CITY OF ALBUQUERQUE

Re: Family Dollar Store
2801 4th St. NW
Traffic Circulation Layout
Architect's Stamp 4-10-17 (H14D107)

DRAINAGE AND TRANSPORTATION INFORMATION SHEET (REV 10/2015)

SHEET TITLE:
TRAFFIC
CIRCULATION
LAYOUT (TCL)

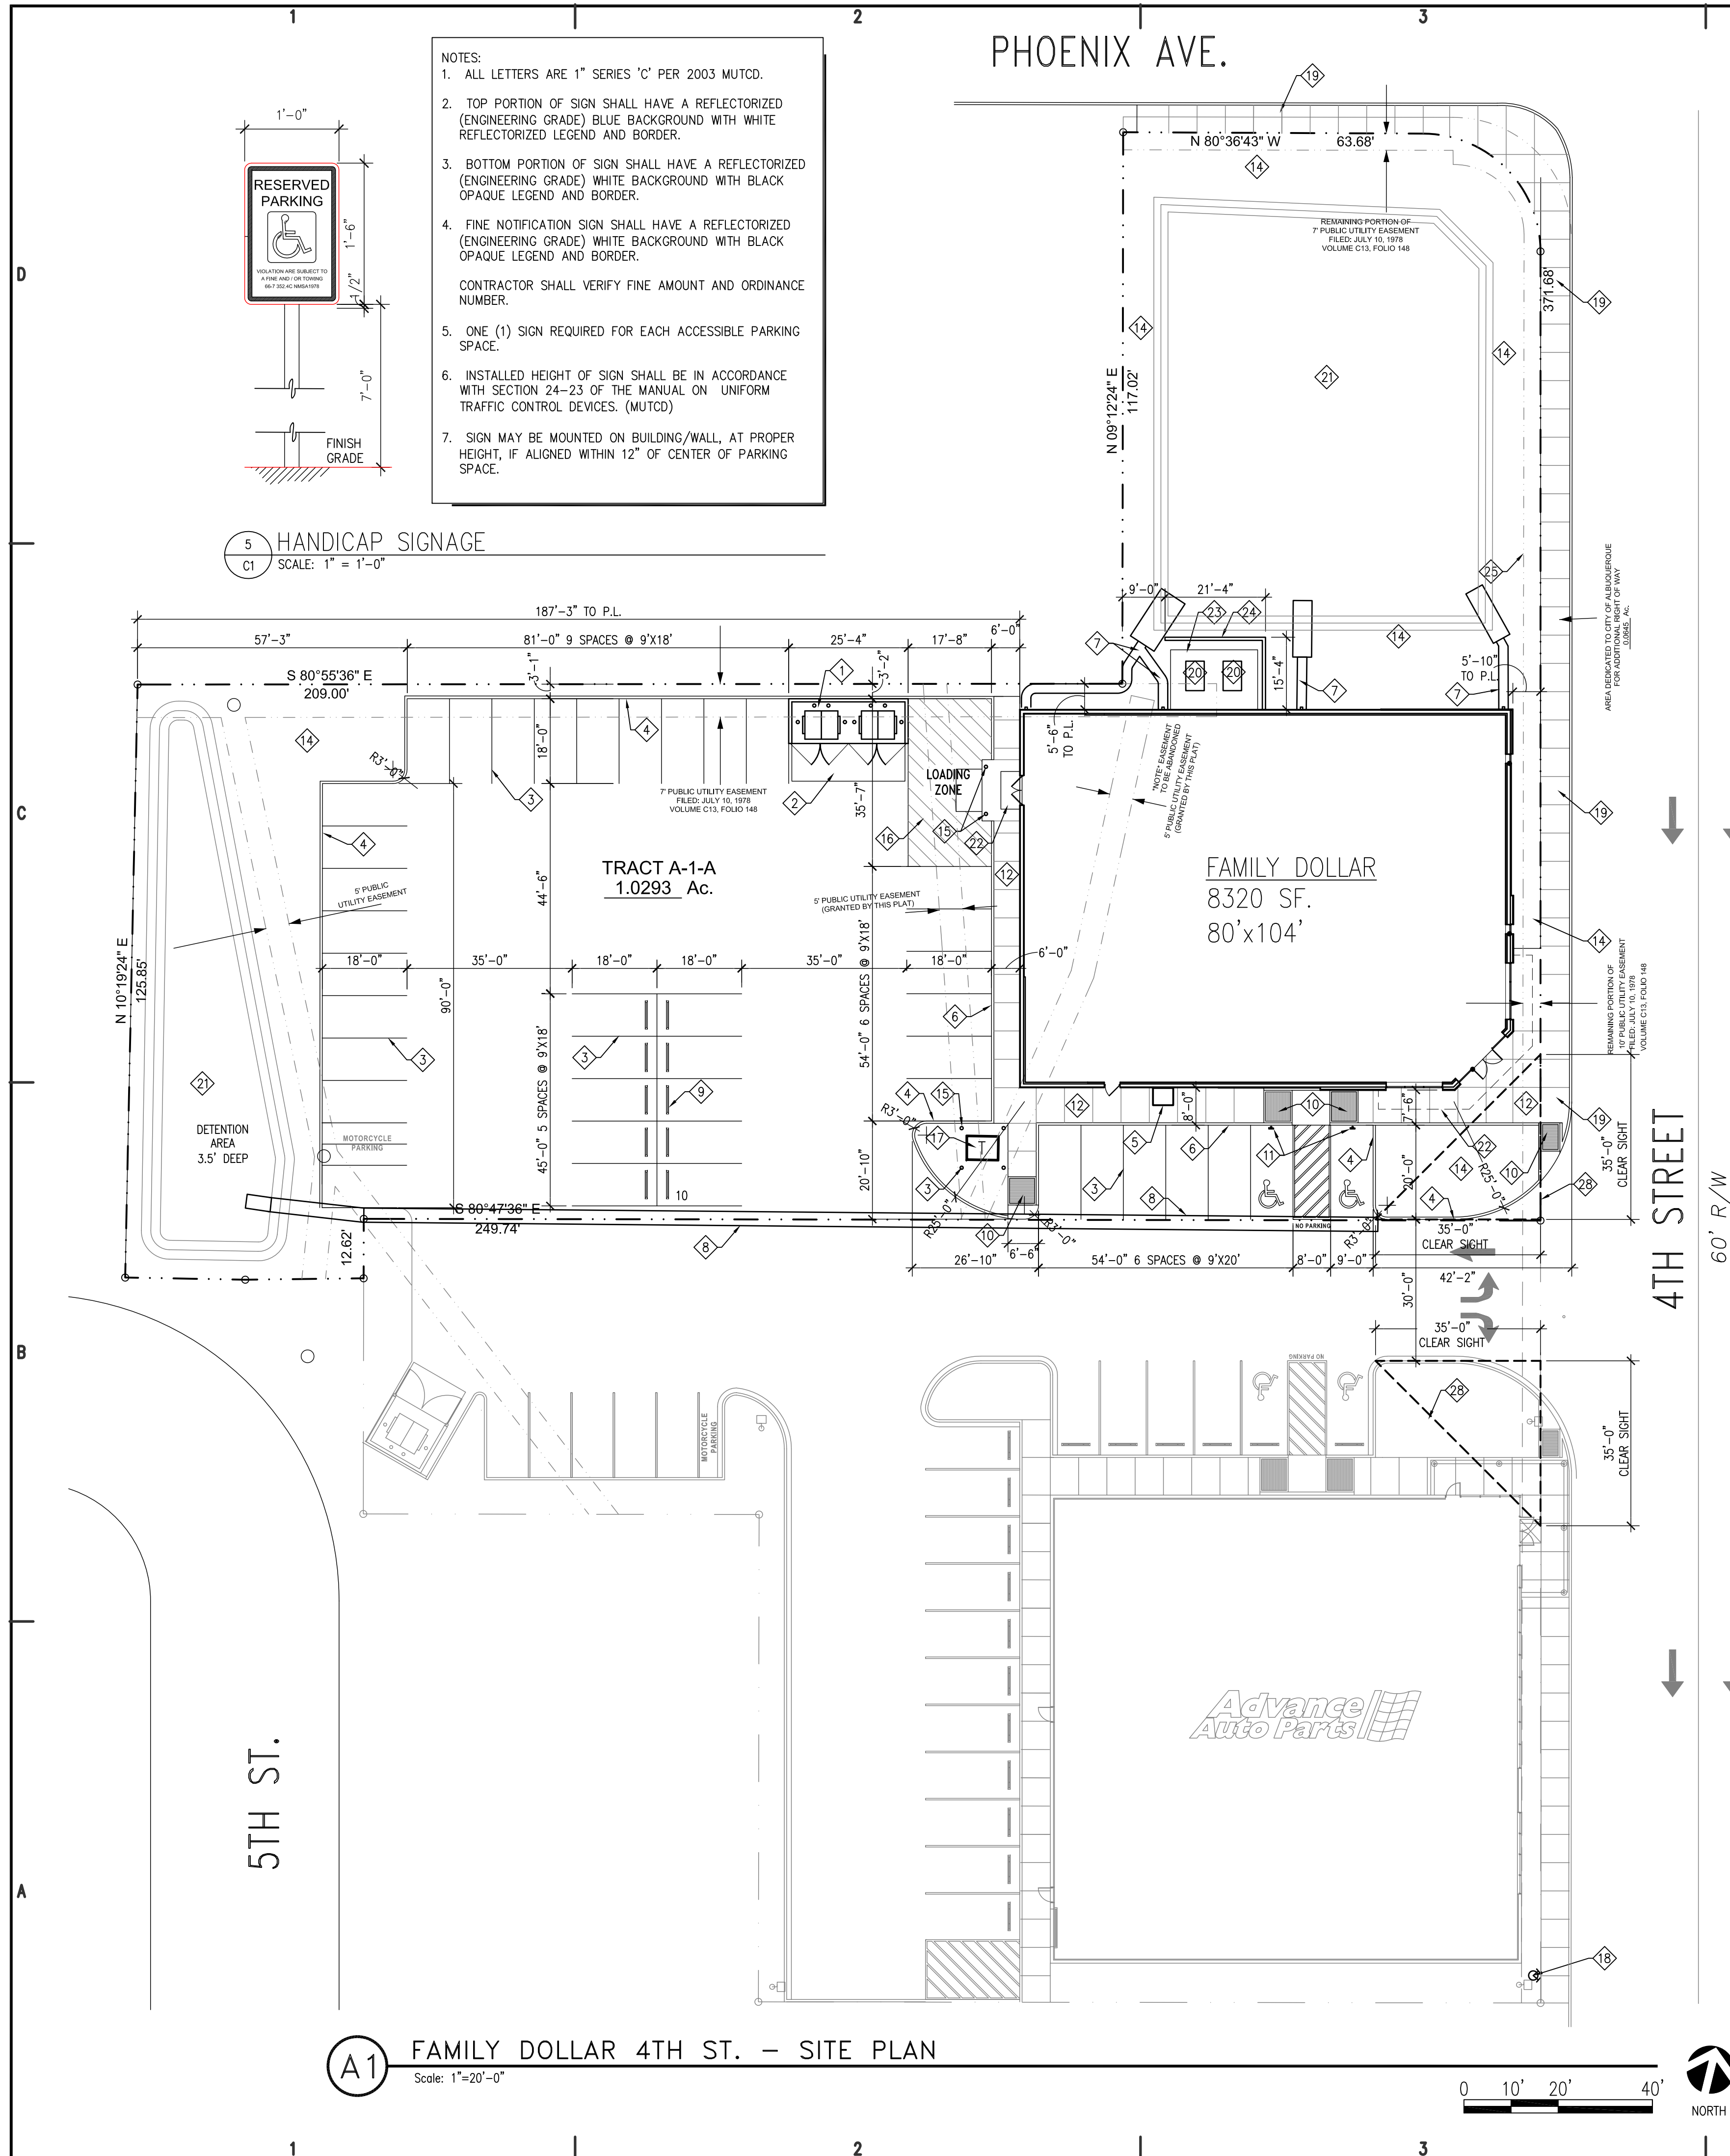
1. Identify all existing access easements and rights of way width dimensions.
2. Include a note for existing drive way closing and use standard drawing #s when applicable.

3. Parking spaces cannot cross over lot lines. Parking spaces on the south end of the building can be shrunk to 18 feet to keep inside the site boundary.

4. Please dimension motorcycle parking spaces.
5. Please add the following note to the clear sight triangle: "Landscaping and signage will not interfere with clear sight requirements. Therefore, signs, walls, trees, and shrubbery between 3 and 8 feet tall (as measured from the gutter pan) will not be acceptable in this area."

6. The ADA curb ramp on the northeast side of the site at the intersection should be brought to current ADA Standards.
7. Please include a copy of your shared access agreement with the adjacent property owner.

8. All vacated and granted easements must be approved before approval of TCL. Please provide plat showing approved easements.
